From: Gilmore, Tyler J [tyler.gilmore@pnnl.gov]
nt: Friday, November 22, 2013 2:07 PM
Subject: McDonald, Jeffrey
RAI #1 Responses
Attachments: EPA_RAI1_for_FG-RPT-017-Final.pdf

Subject: Request for Additional Information #1 Regarding, FutureGen Applications for UIC Permit nos. IL-137-6A-0001, -0002, -0003 & -0004, dated October 31, 2013

RAI #	Page	Doc. Sec.	Par.	EPA Comment / Question / Request	FutureGen Response	Footnote / Reference Citation
10-31-2013_001	2.26	2.3.1.1	1	<p>The Illinois State Geological Survey (ISGS) recently acquired a new 120-mi long seismic reflection survey across central Illinois as part of a DOE-sponsored research project to characterize reservoir rocks for geologic storage of carbon dioxide. The continuous east-west line extends from Meredosia to southwestern Champaign County (Figure 2.14). This line, which is currently under re-processing, will supply additional information about the structure of the sedimentary layers which will be correlated to the observations made on both profiles L101 and L201.</p> <p>"Future efforts at Morgan County will also include the acquisition of vertical seismic profiling data in the stratigraphic well to better evaluate the

Laboratory Cement Test Report-CAR10-364 EverCRETE-5

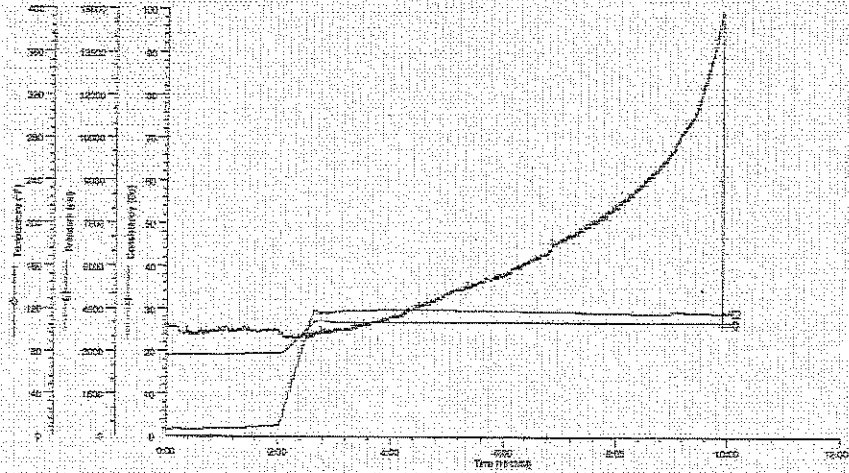
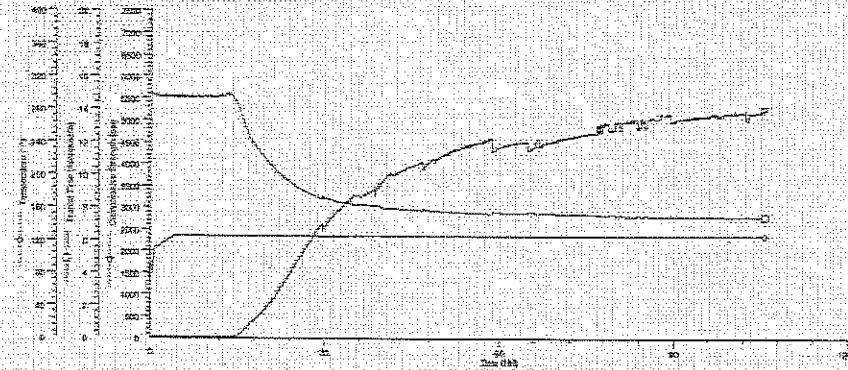
10-31-2013_007	EPA Form 7520-14	5			<p>EPA Form 7520-14 has been completed for open-hole and cased-hole completions with laterals of 1,500 ft and 2,500 ft (4 forms, in Appendix B). These forms were unintentionally missing in the UIC Permit Application and are being submitted with this response.</p>
10-31-2013_008	EverCrete Cement Information			6	<p>(1) The slurry volume (yield) is 1.12 ft³/ sack. (2) The slurry weight is 15.82 lb/gal. (3) Lab analyses of the EverCRETE-5 cement blend and a technical report are also attached (Appendix C).</p> <p>Note that the Alliance plans to use a Class H cement, and the product brand, EverCRETE-5, is an example of a Class H cement.</p>
10-31-2013_009	Casing & Retainer in Figure 6.2	6.5		6	<p>The carbon-steel casing will be run to a depth of 3,400 ft and stainless steel casing will be run from 3,400 ft to 3,950 ft. For clarity, an updated version of Figure 6.2 is attached in Appendix D. For consistency, Figures 4.4, 4.5, and 6.1 have also been updated and are provided in Appendix D.</p>

The CO₂ resistant cement that will be used for the injection interval has been engineered to be more resistant to degradation by wet CO₂ and carbonic acid than traditional Portland cement-based well cement. The primary improvement in the CO₂ resistant cement over traditional Portland cement is the reduction in volume of the lime and water in the set cement. The increased compatibility of the CO₂ and the CO₂ resistant cement compared to CO₂ and Portland cement is described below:

- The CO₂ resistant cement has very low Portland cement content in the set cement volume. Portland cement is the main component that goes through the carbonation process. By reducing its content, the durability of CO₂ resistant cement is significantly enhanced. Despite a low Portland cement content, high compressive strength is achieved (above 2,000 psi) over a wide density range (12.5 ppg -16 ppg). Even though this system has a small amount of Portland cement, it does go through the carbonation process, but it is self-limiting and prevents further leaching.

- The CO₂ cement system is designed with an optimized particle size distribution (PSD). Consequently, the CO₂ resistant cement has very high solids content, i.e. water content is reduced significantly, compared to a conventional cement system. Low water content significantly reduces the permeability of the set cement matrix and strongly reduces the cement degradation rate due to CO₂ reaction.

- The CO₂ resistant cement is a lime (Ca(OH)₂) "free" system compared to conventional Portland cement; for example, a neat 15.8 ppg set cement has about 13% "free" lime content. The reaction between CO₂ and cement is primarily due to the presence of free lime. The rate of the reaction and the amount of calcite formed from the reaction is dependent on the amount of free lime present. This reaction creates porosity in the cement. Eventually, the CO₂ and water mix to form carbonic acid which will dissolve the calcite, which further increases the porosity of the cement.

- The dissolution of calcite degrades the mechanical properties of the Portland cement. For longer CO₂ exposure, Portland cement integrity is reduced by the dissolution of calcite under acidic conditions. By having a lime-free cement system, the resistance of the cement to degradation in a CO₂ environment is effectively increased compared to a conventional Portland cement system.
